02-February, 2024 Revised 25 March, 2024

Pine Knoll Shores  
Public Services Building

### Addendum 1

**BD-1**

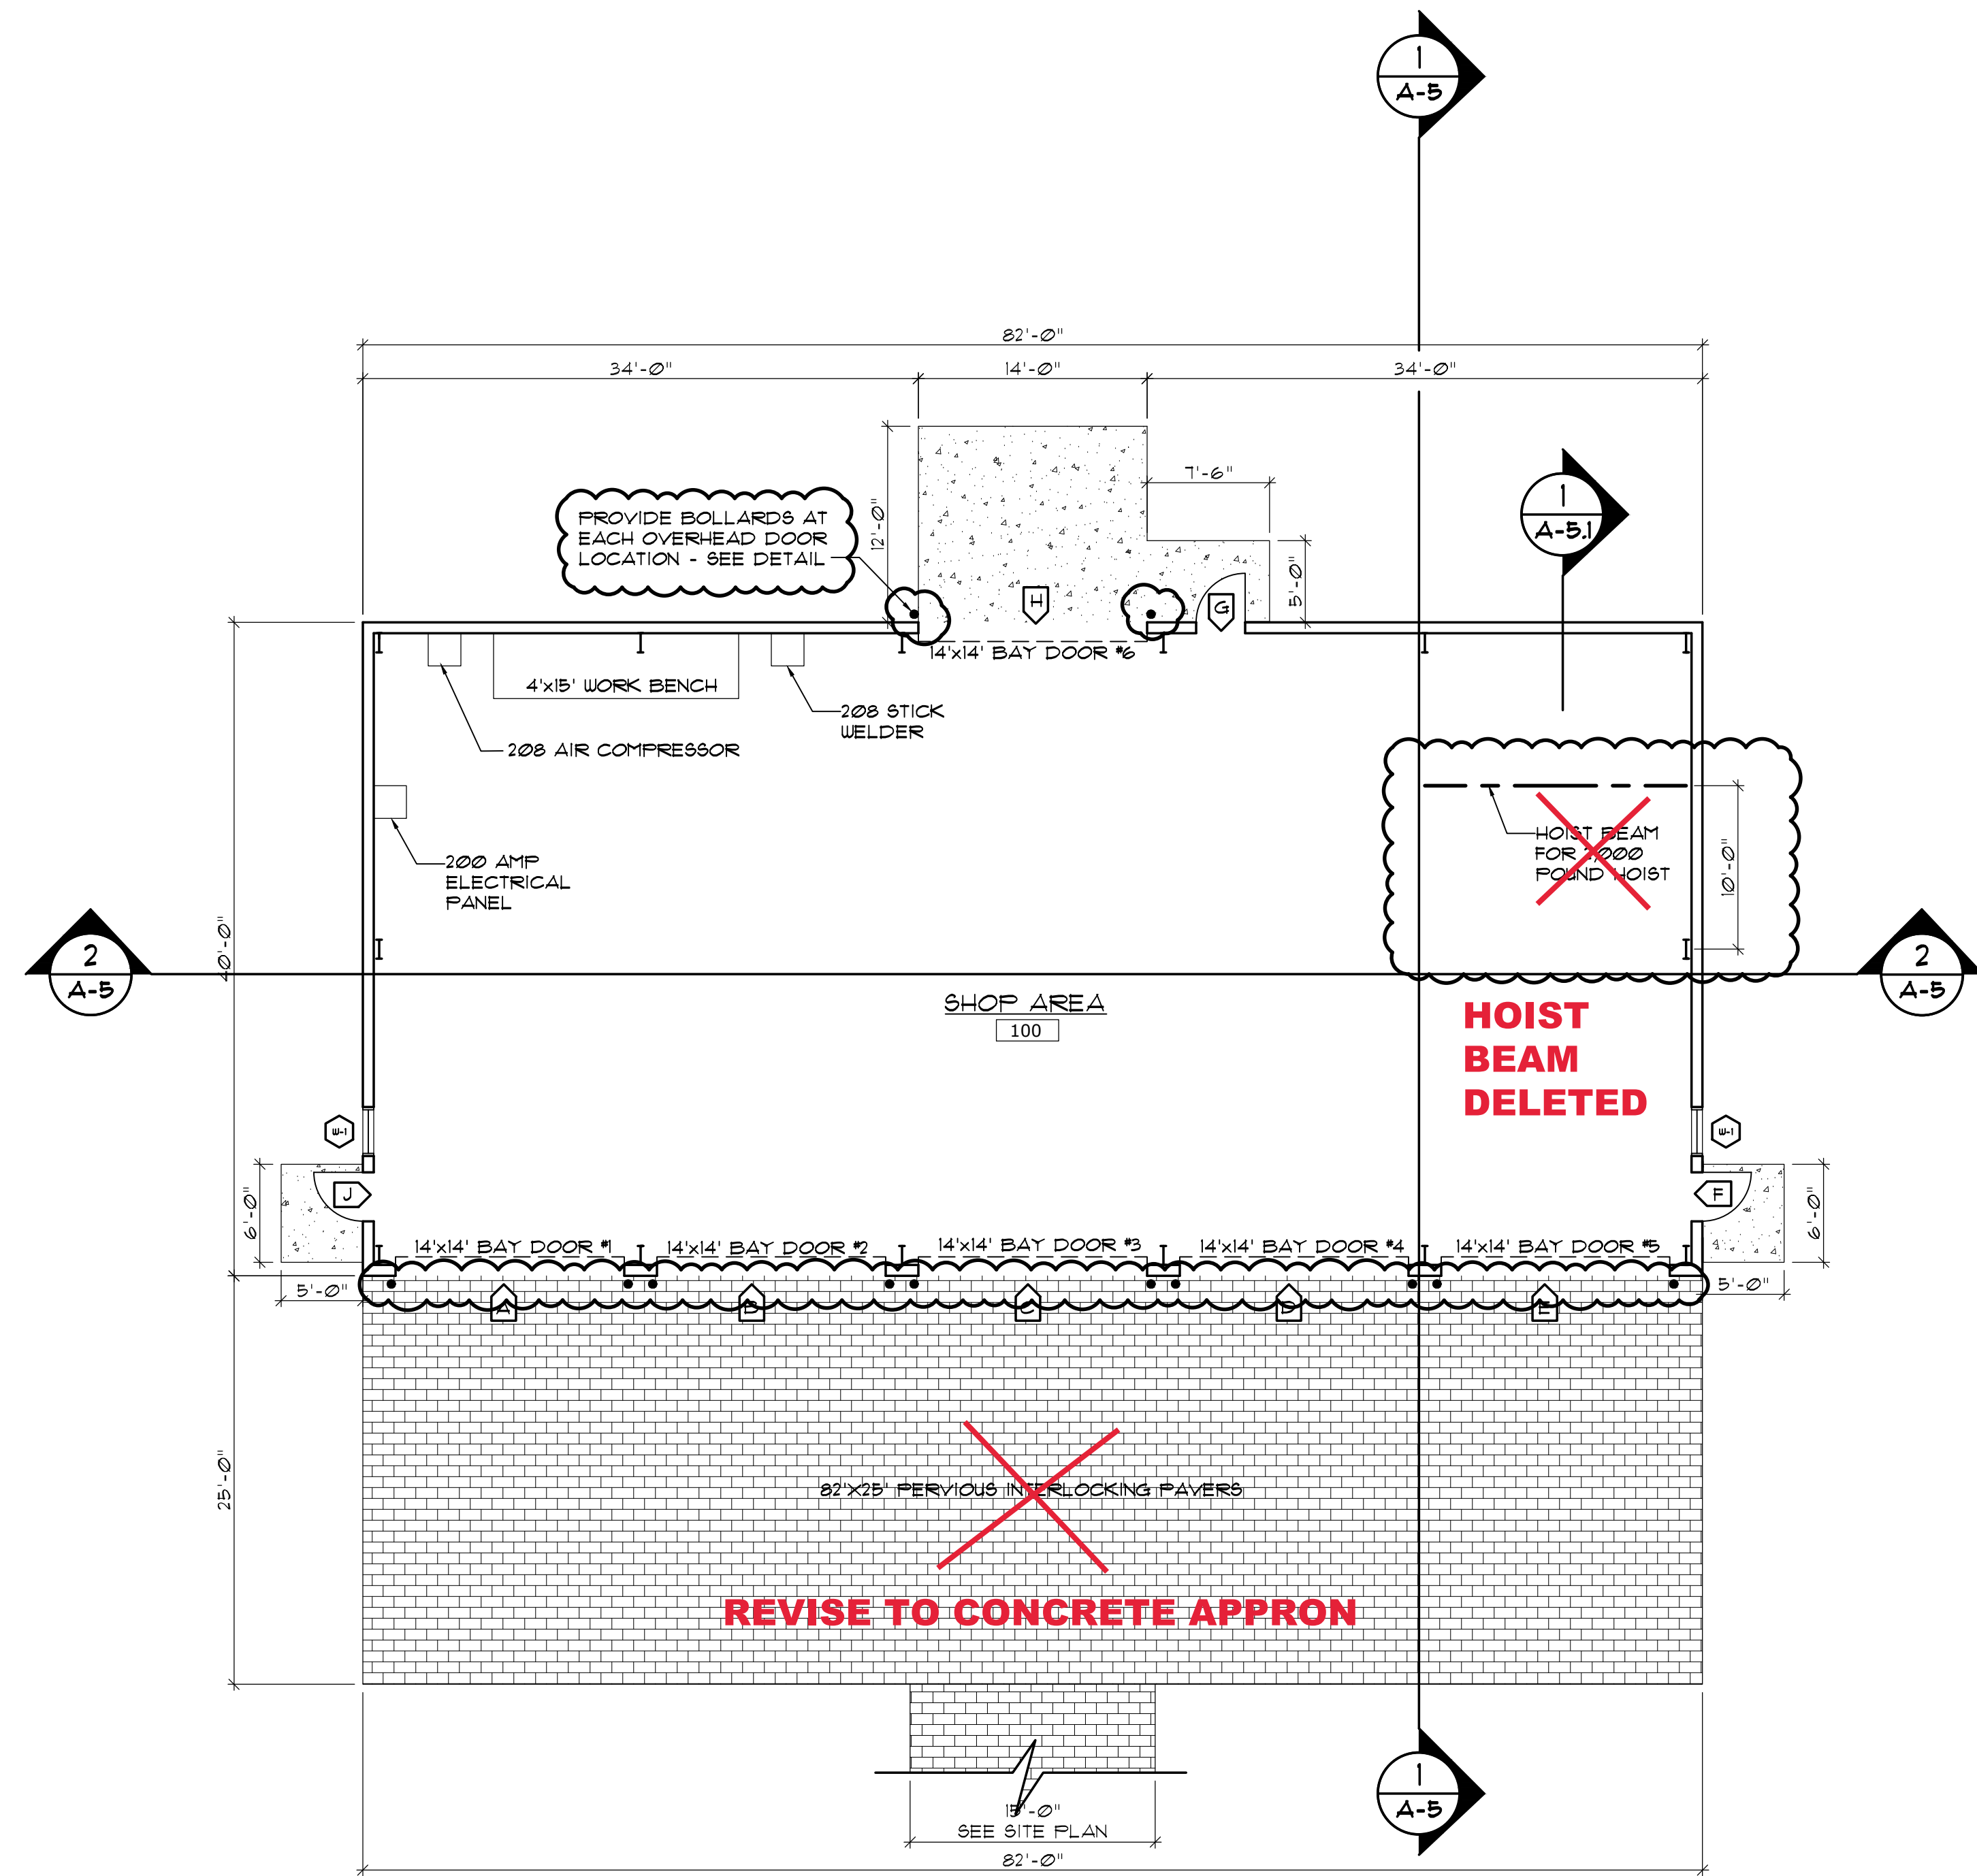
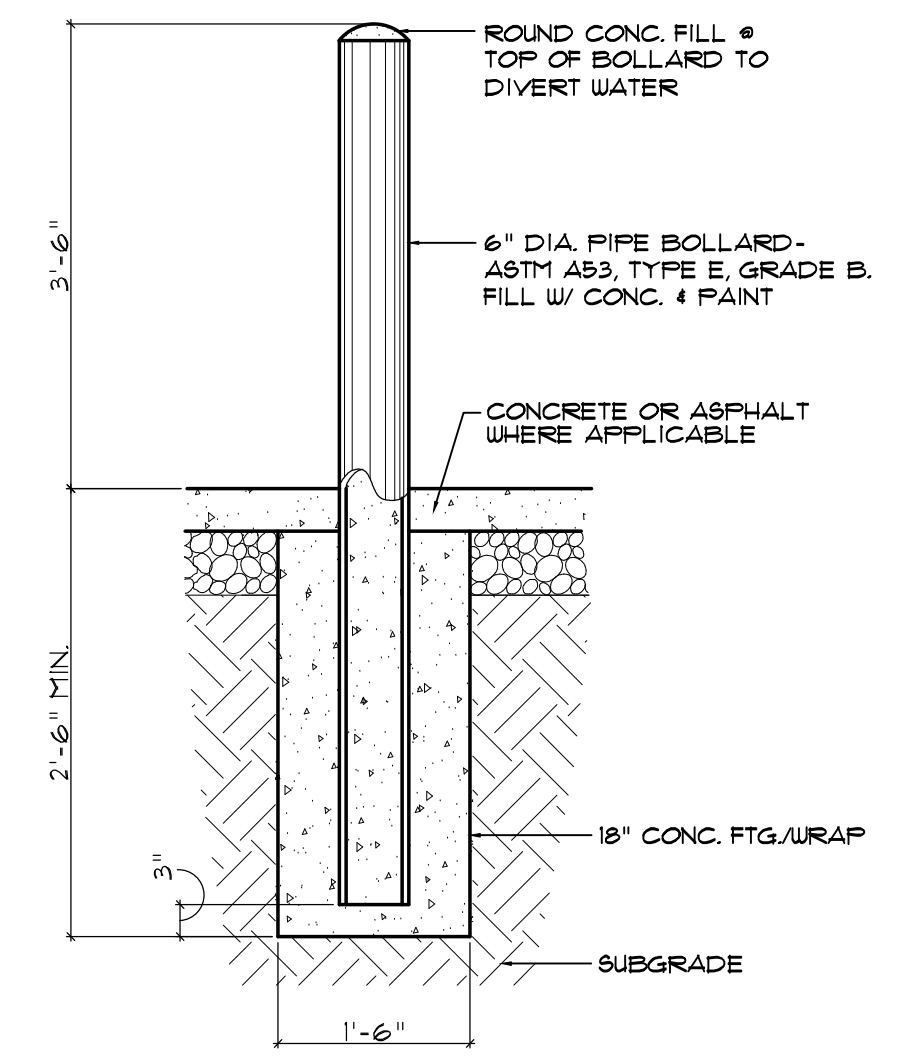
- See BD-1 for ~~hoist location and bollard locations~~ which are to be included in base bid. ~~2,000 pound hoist to be specified in Addendum 2.~~ Deleted

- Clarification: Air compressor, work bench and welder to be provided by Owner.
- Clarification: Design loads for building are shown on SK1.1. Soil seismic Soil Class to be "D". Roof collateral load to be 10 psf (except for hoist beam location, provide for 2,000 pound hoist as shown on BD-1). Wind speed 144mph. All other requirements shall be by PEMB engineers. Diagonal bracing can be installed where it does not interfere with door openings. Portal frames can be used where they do not interfere with doors. The minimum height under the steel frame is 14'-0" A.F.F.

**BD-2**

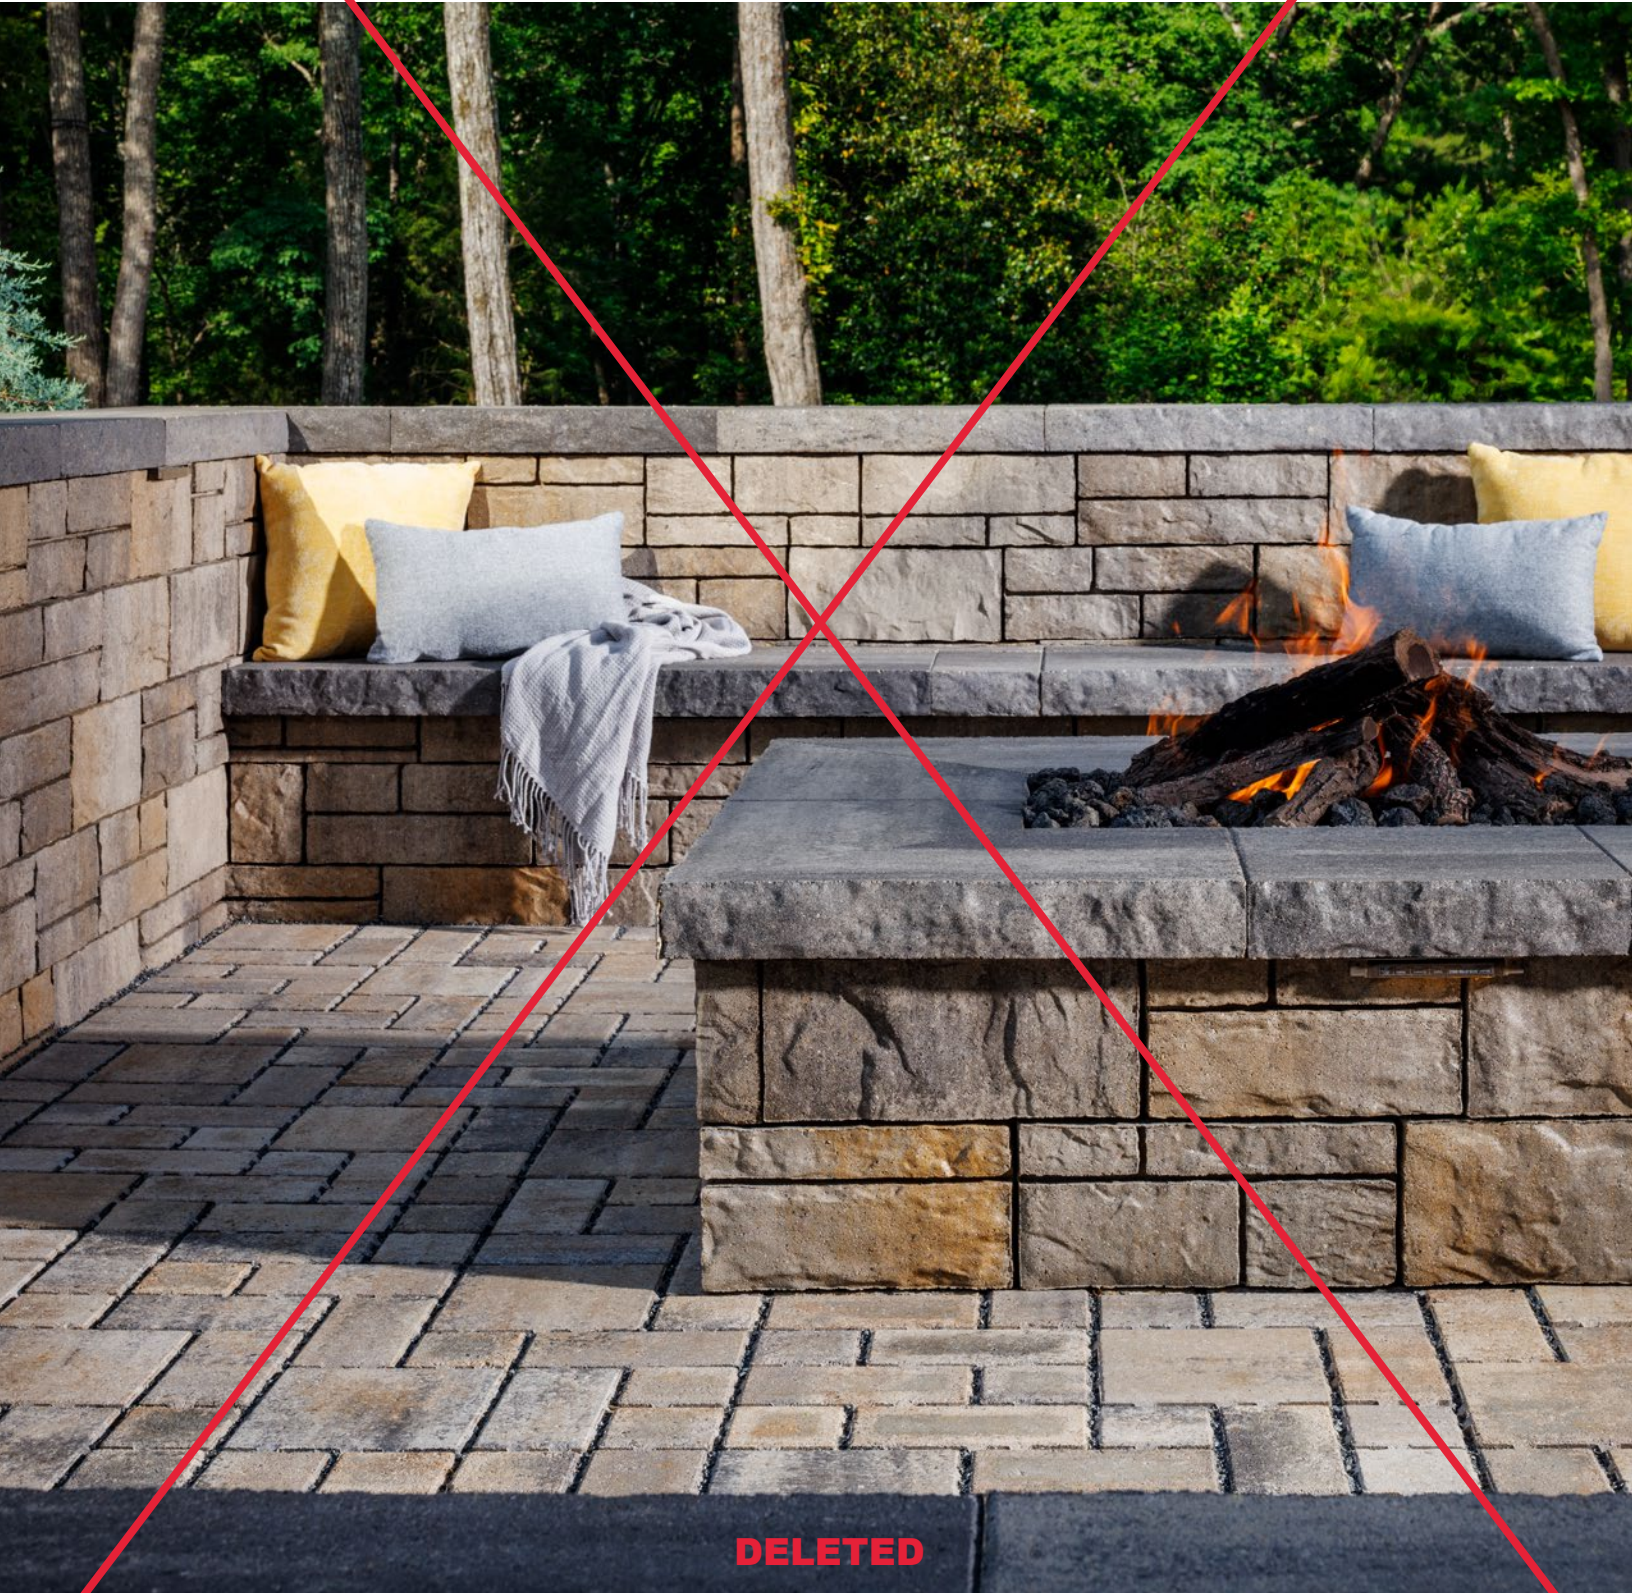
- Clarification: Field paint is required on main frames and secondary framing as per 133419. Deleted
- Drawing, Site Drainage Plan: Driveway to be pervious interlocking pavers in lieu of pervious gravel driveway. (All pervious pavers to be Aqualine 4 1/2" x 9" x 3 1/8" in running bond. See attached BD-2 and Aqualine cut sheet). Deleted
